# UPDATE PRIOR TO SALE NOTICE

Global Service Action  
Number: D093  
UPS0726-1

<b>Subject:</b>  <b>V8 Badge Not Installed</b>	Publication No.: D093 UPS0726-1
	Model: Range Rover Sport (L1)
	Model Year: 2026
	Date of Issue: 04 March 2026
	Expiry Date: 30 March 2028

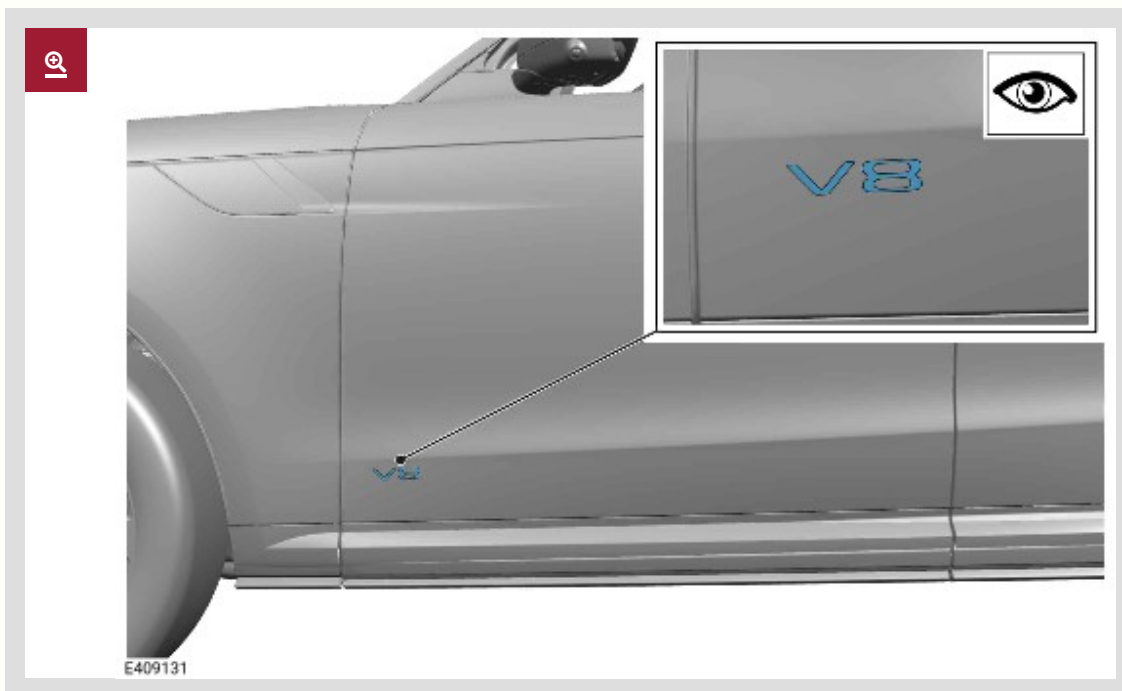
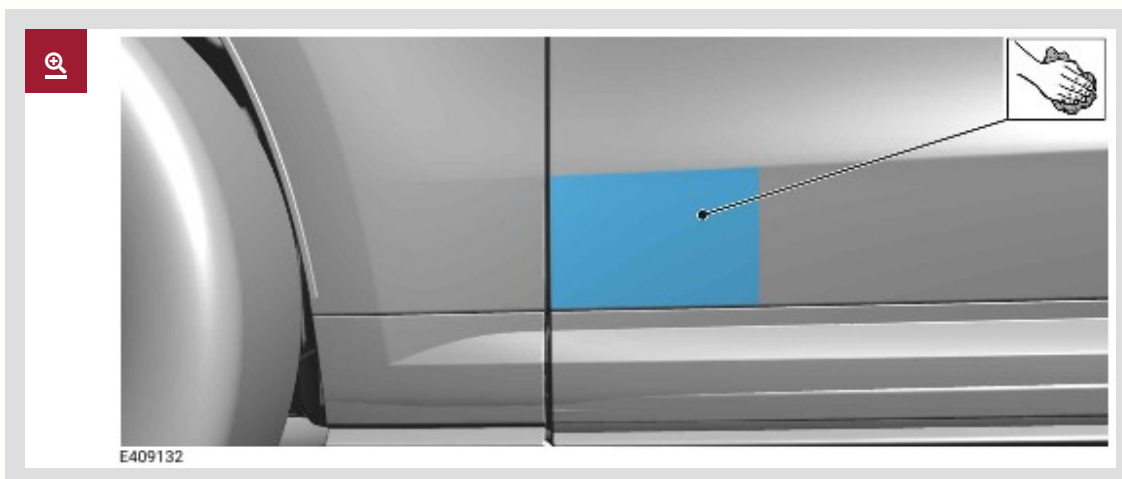
1. Inspect the left side and right side front doors in the area shown in the illustration.

- If the V8 badge **IS** installed as shown in the illustration, do not continue with the D093 campaign. Release the vehicle.
- If the V8 badge **IS NOT** installed as shown in the illustration, continue to step 2.

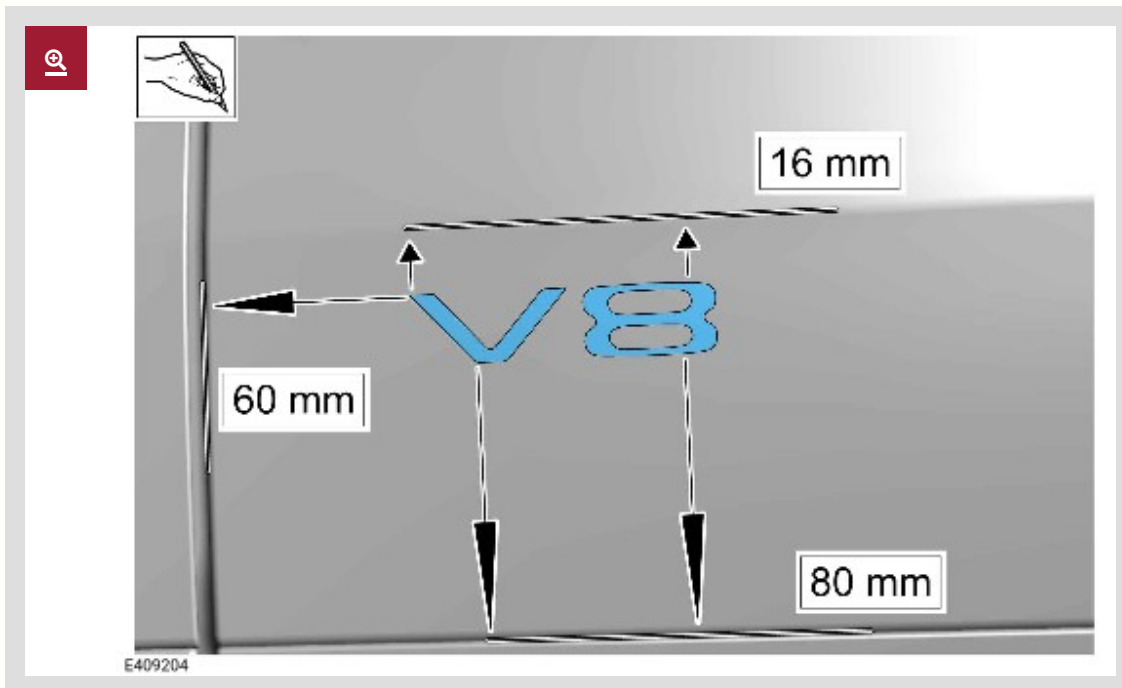
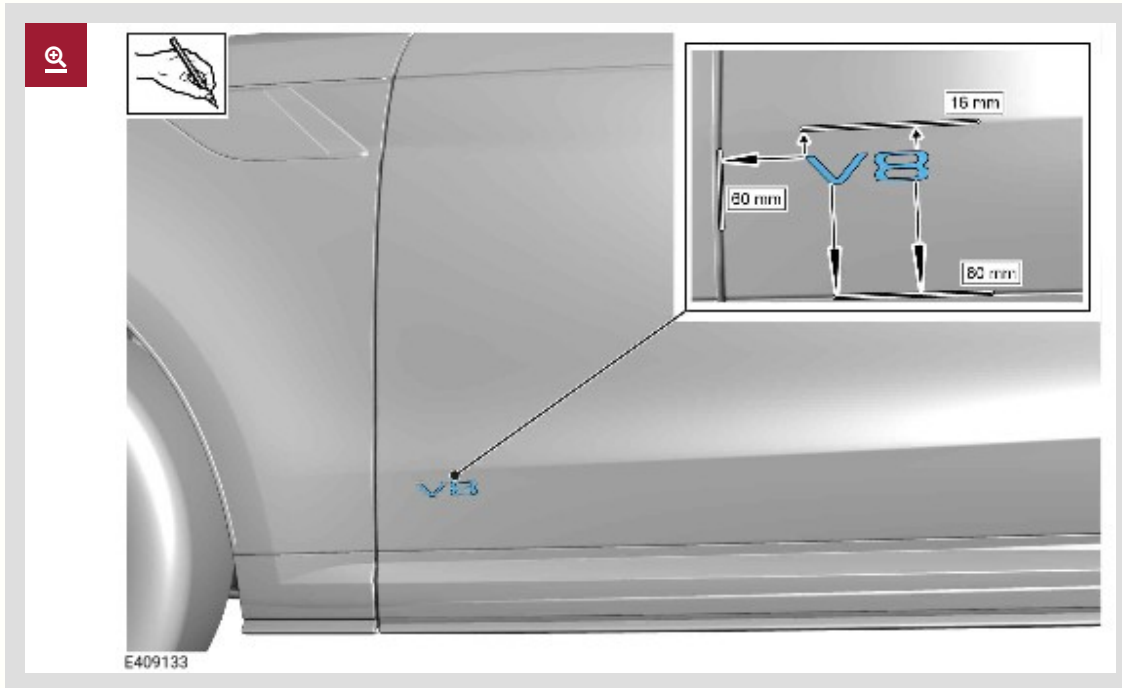
- For successful adhesion, the temperature of the badge adhesive must be at least 20°C. Heat the component if required.
- The temperature difference between the badge adhesive and the vehicle surface must be less than 5°C.

Install the V8 badge to the left side and right side front doors, using the dimensions shown in the illustration.
